Domino's Subdivision

City of El Paso — City Plan Commission — 12/06/18
SUSU18-00097 — Major Combination

EXISTING

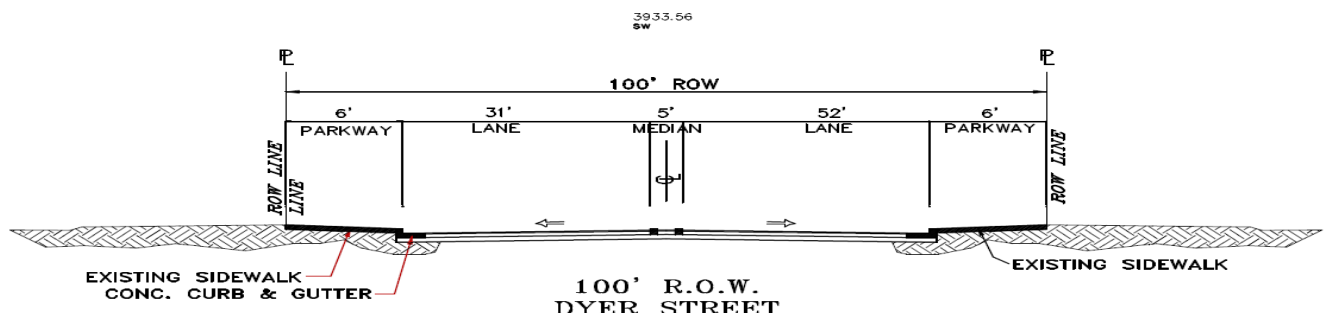
The applicant's request is to allow the existing parkway configuration to remain. The existing 6' parkway consists of a 6' sidewalk abutting the curb and does not include landscaping.

ATTACHMENT 3

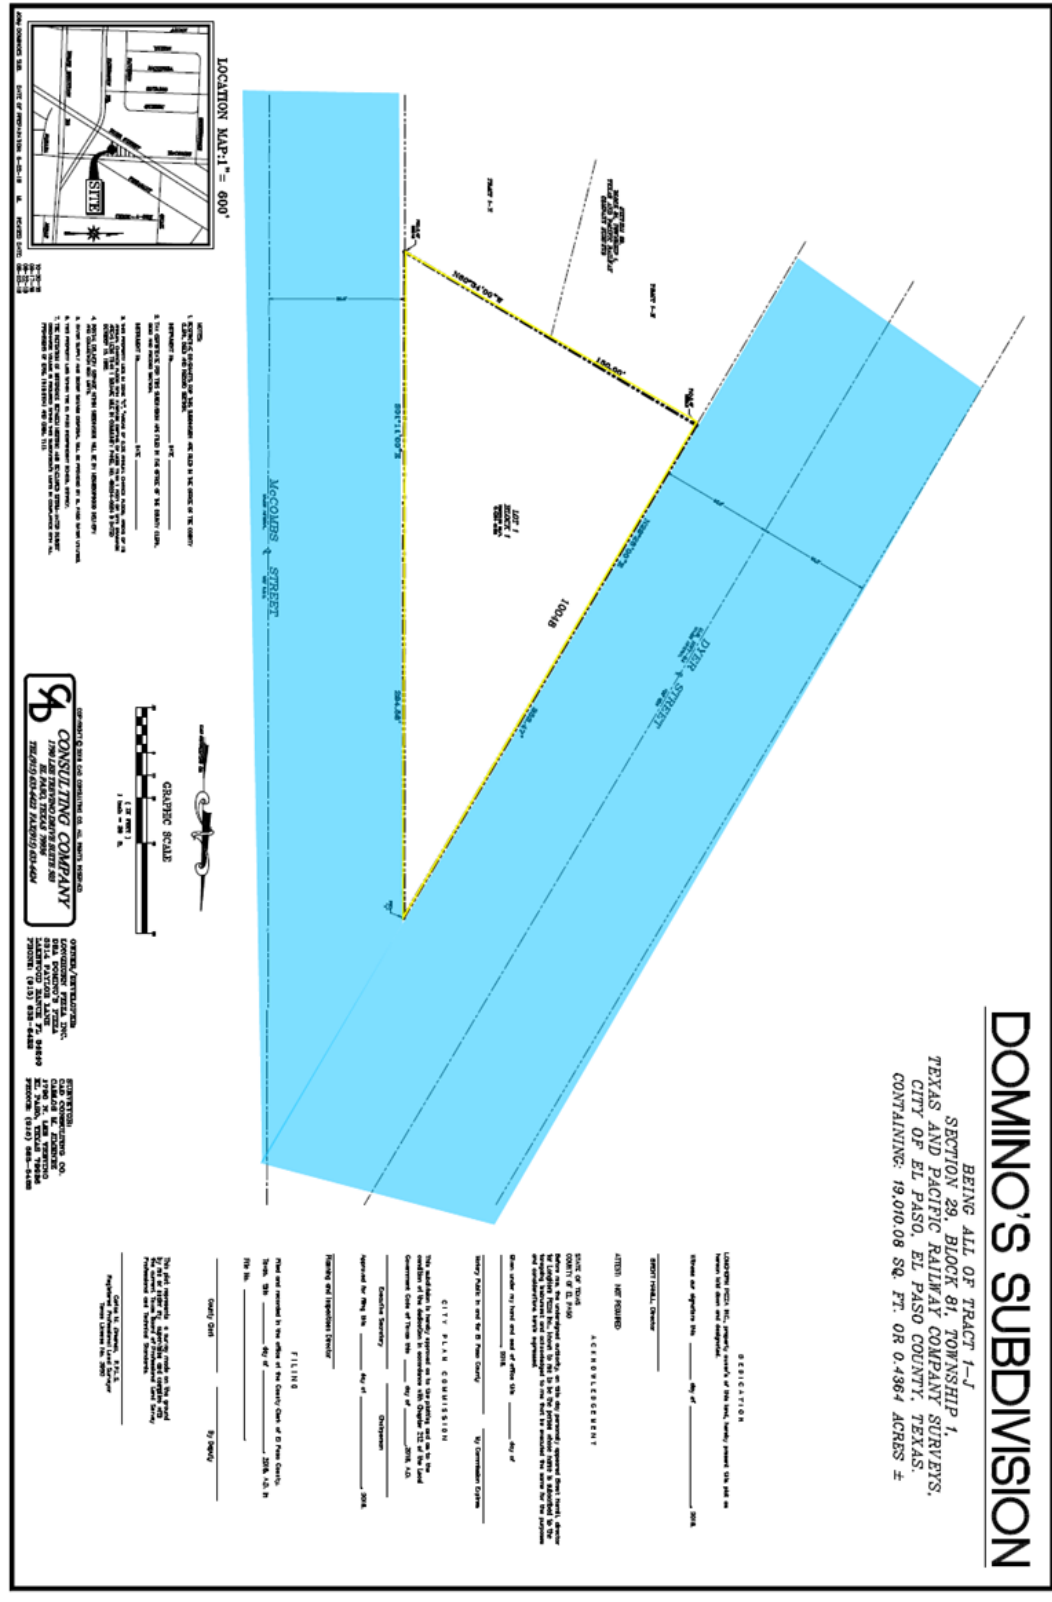
1. Show delineation of proposed private pond.
2. Delineate expansion joints between sidewalks and driveways separation. Not as one monolithic slab (DSC 6-17).
3. Sidewalk ADA ramps at the intersection of Dyer and Mc Combs must be aligned to existing ramps to allow crossing Mc Combs and be in compliance with TAS standards.
